Abir Fashions (Extension)

Plot #44, Road #02, Kutubail, Fatullah, Narayanganj.

11 February 2024

2. Observations:

Observation-2: Lack of information in soil test report (Production Building-5).

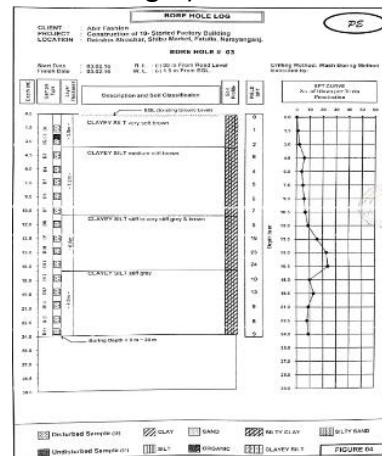
Description: Recommendation for foundation is given based on 12 borehole data but no borehole layout is given in soil test report. Also, bore log data is provided only for 3 boreholes. The building engineer is required to submit the complete soil test report with all bore log data along with design report to the RSC.

Observation-8: Dampness on brick wall (Production Building-5).

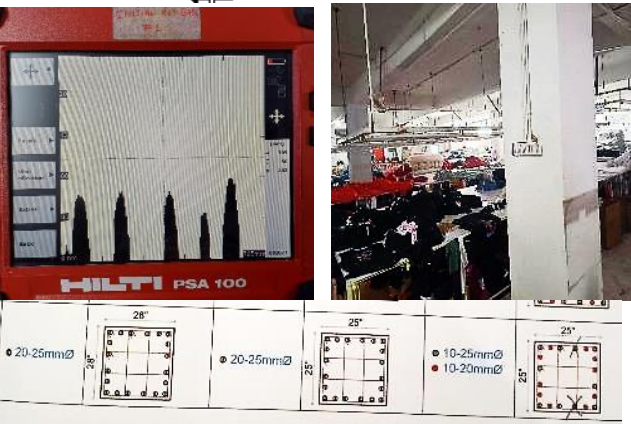
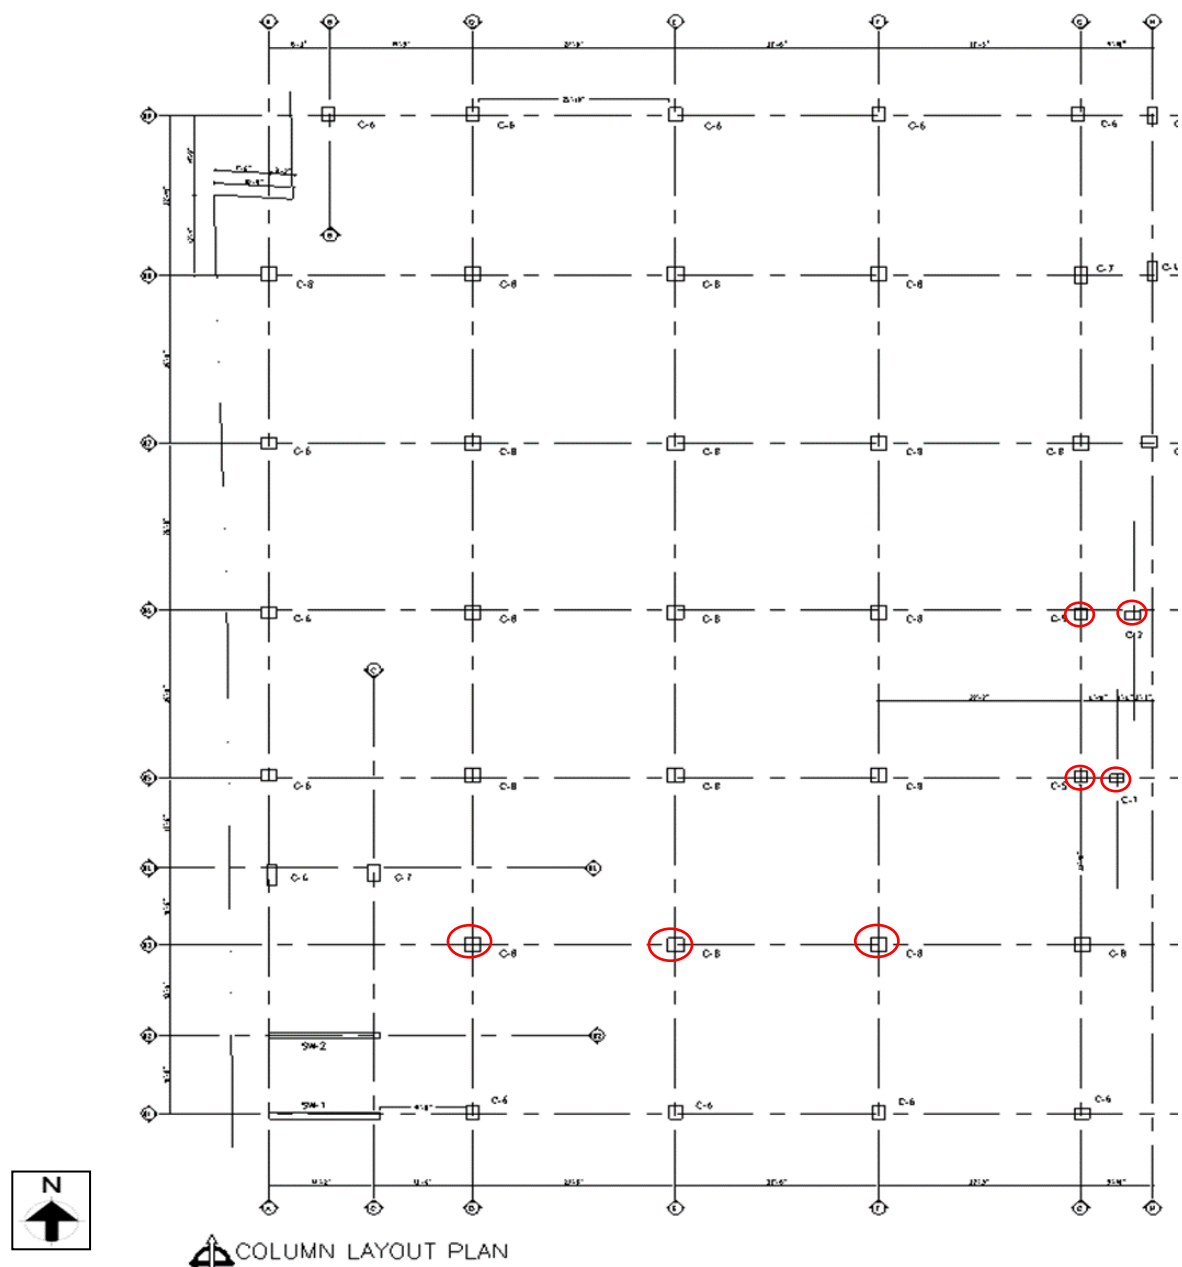
Description: Dampness was found on brick wall. The building engineer is required to repair dampness with a suitable method.

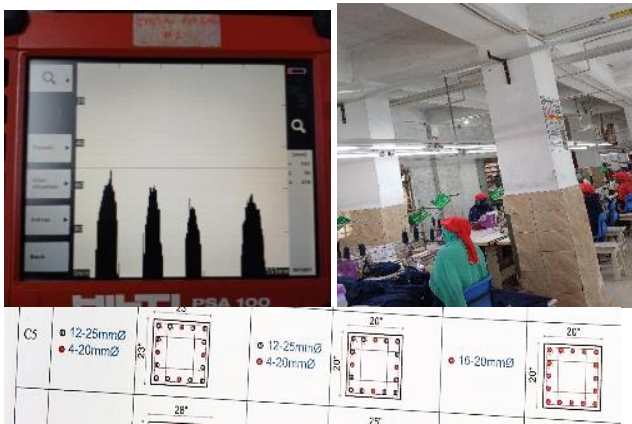
Column C8 (625X625) re-bar profile found by scanning 6/5 (18 no's) instead of 6/6 (20 no's)

Description: During the inspection, discrepancies were observed between the provided drawing and on-site conditions. RC column re-bar profile, OHWT detailing, and stair detailing mismatches were observed. Also, no information was available for the ground floor extended shed and the north staircase. The building engineer is required to survey the whole structure and update the drawing reflecting on-site condition.

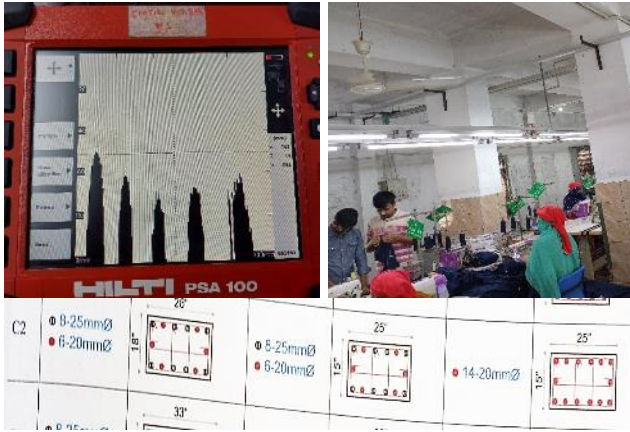
Column C5 (500X500) re-bar profile found by scanning 4/5 (14 no's) instead of 5/5 (16 no's)

Column C2 (625X375) re-bar profile found by scanning 5/3 (12 no's) instead of 6/3 (14 no's)

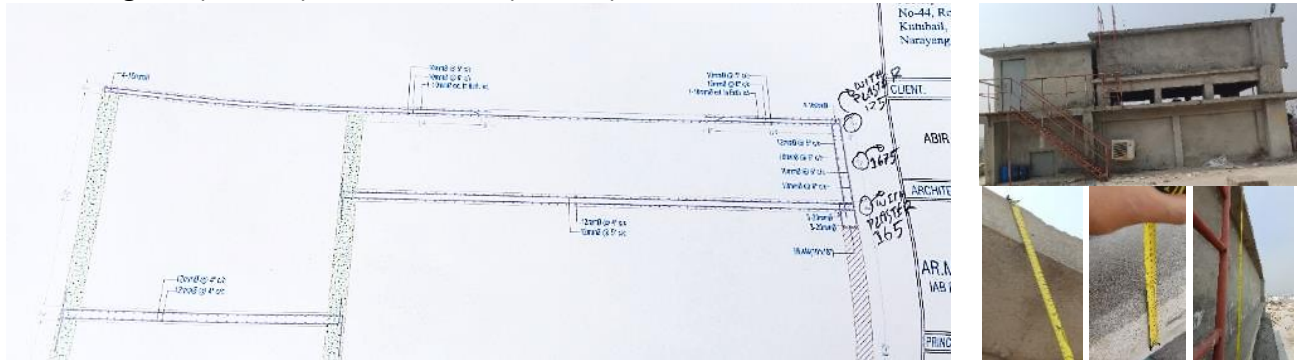
Column C1 (375X500) re-bar profile found by scanning 4/3 (10 no's) instead of 5/3 (12 no's)

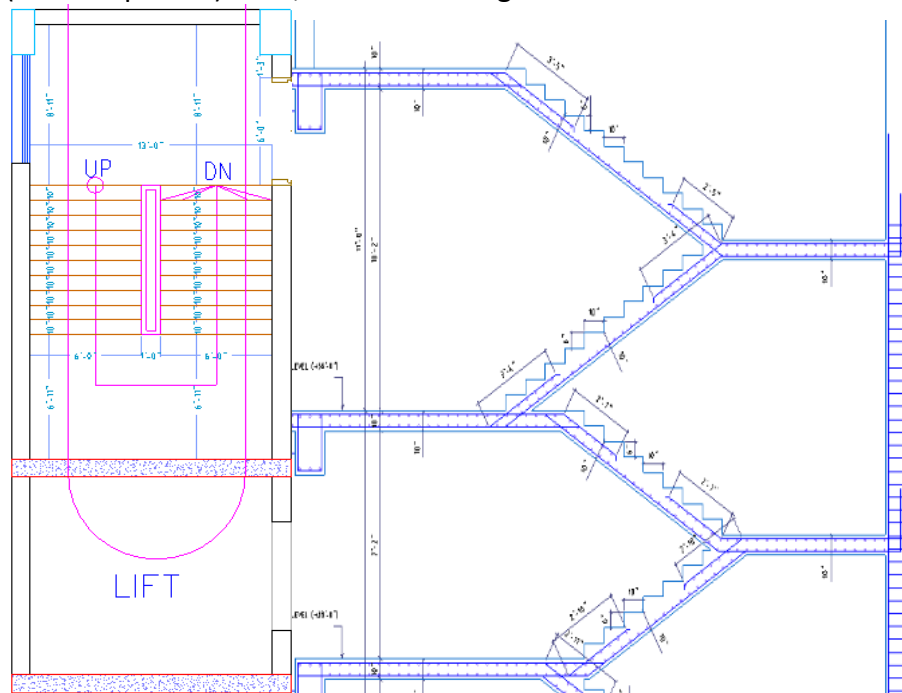
RC OHWT: Bottom slab thickness found 165mm (with both side plaster) instead of 200mm (without plaster) as well as top slab thickness found 125mm (with both side plaster) instead of 125mm (without plaster). Also, water tank height observed 1800mm instead of 1325mm.

Observation-11: Lack of material test report (Production Building-6).

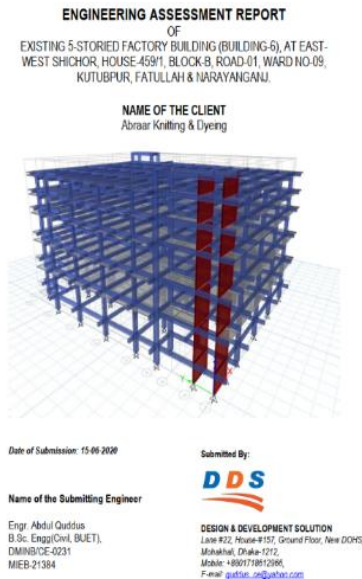
Description: During the inspection, 02 sets of cylinder test report (column=1 and beam-slab=1) were provided which doesn't meet the frequency of testing requirements as per BNBC (Part VI, Chapter 5.12). The building engineer is required to verify in-situ material strength by further testing (minimum four concrete cores from lower tier building columns). Submit the test report and necessary calculations along with design report to the RSC.

Observation-13: Prepared load plan to be revised (Production Building-6).

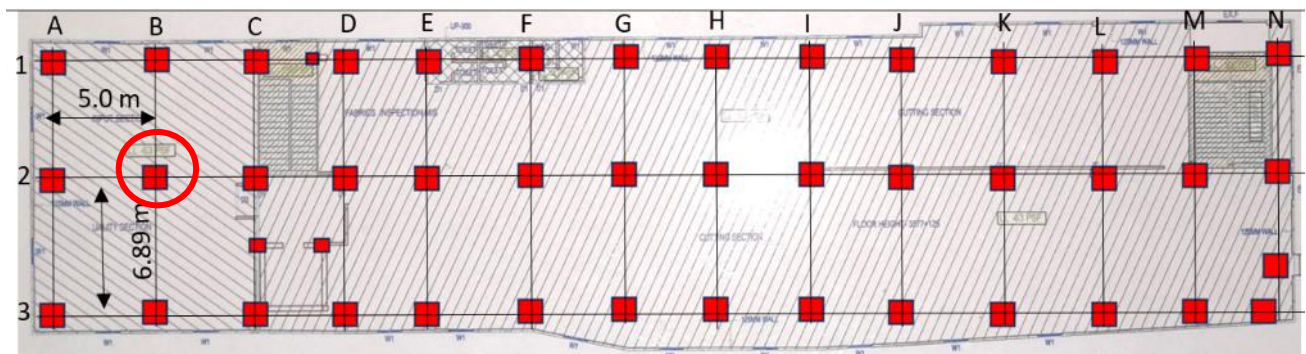
Description: This Building was constructed between May 2017 and August 2019 confirmed by factory management. However, typical live load considered as 5 Kpa in all floors. As per BNBC- Part 6, live load for light storage area is required to be considered minimum 6 kPa. The building engineer is required to revise the load plan as per BNBC requirement and submit the revised design documents to RSC for review.

Column Layout Plan

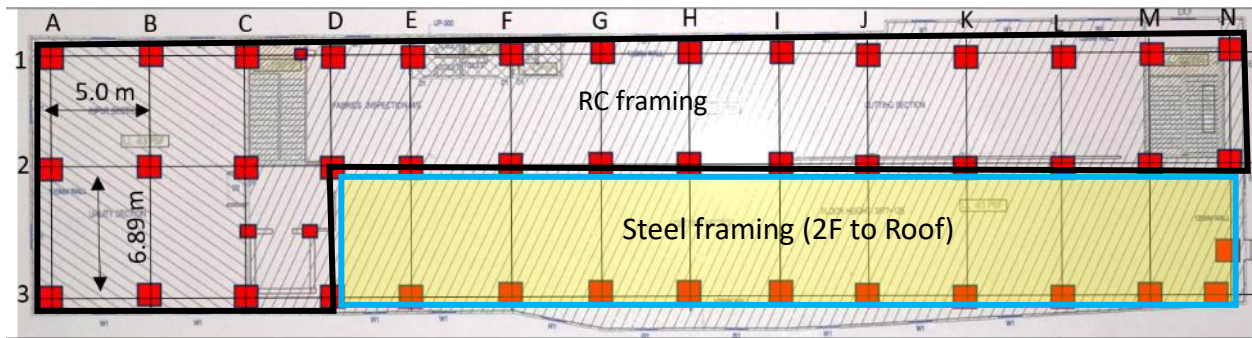
Stressed RC column

Description: Cursory calculation indicates that the marked columns appear to be stressed above normal design limits based on 6 kPa floor live load with minimum concrete strength (16.3 MPa) based on aggregate type. Also, due to lack of drawing, foundation adequacy check was not verified. The building engineer is required to carry out Detail Engineering Assessment (DEA) to review the design, loads and column & foundation stress based on in-situ material strength and soil bearing capacity.

Observation-20: Corrosion on steel member. (Production Building-7)

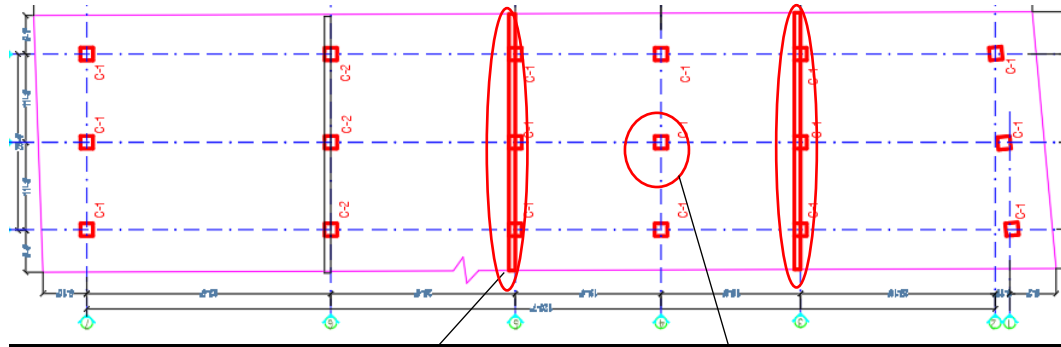
Description: Corrosion was found on steel members. The building is required to identify all corroded member, remove the corrosion, and apply suitable anti-corrosive coating to the affected steel members.

Observation-22: Mismatch in structural drawing. (Utility Building)

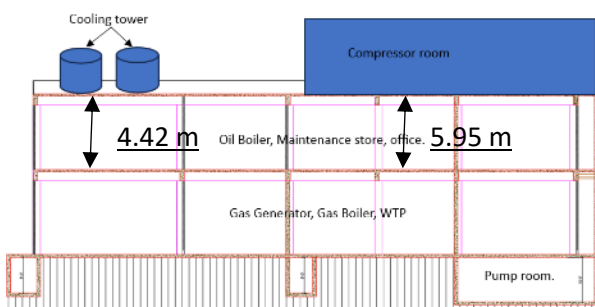
Missing share wall

Missing RC column.

- A RC column and two nos share wall (Marked above) were found missing onsite, which was shown in drawing.
- An undocumented apparently non engineered roof shed was found at roof.
- Floor level was different at 2nd floor, which was not shown in drawing.

The Building engineer is required to survey the whole structure and update the as-built drawings and perform Engineering Assessment (EA).

Different floor heights

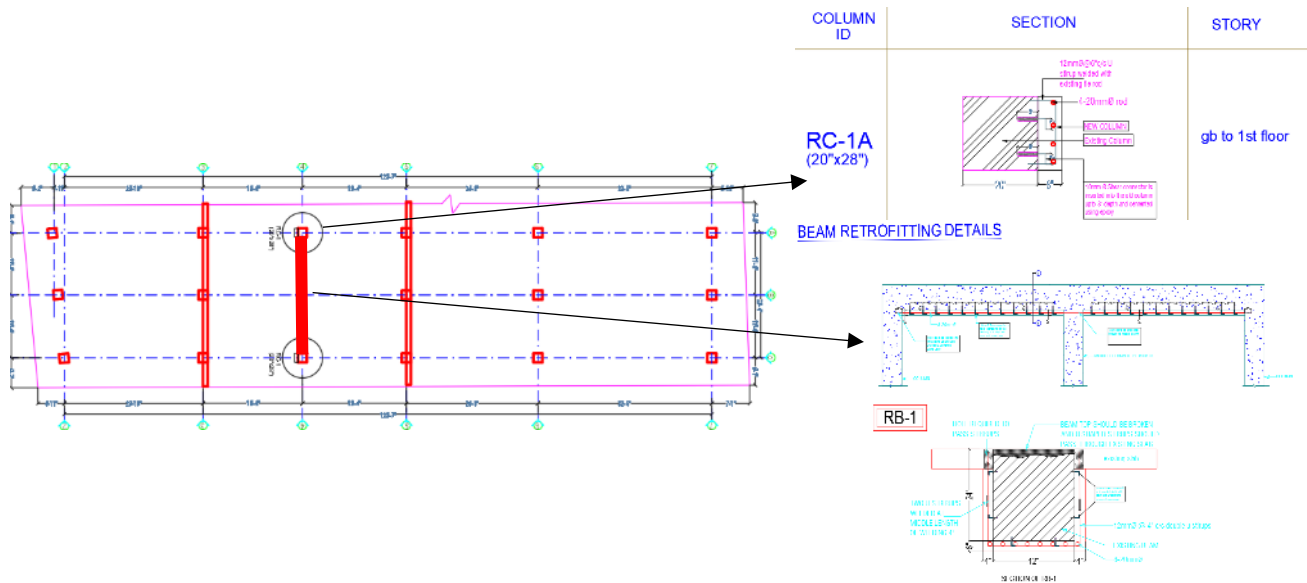
Undocumented roof top shed

Apparently non engineered roof shed

Height=5.95 m

Height=4.42 m
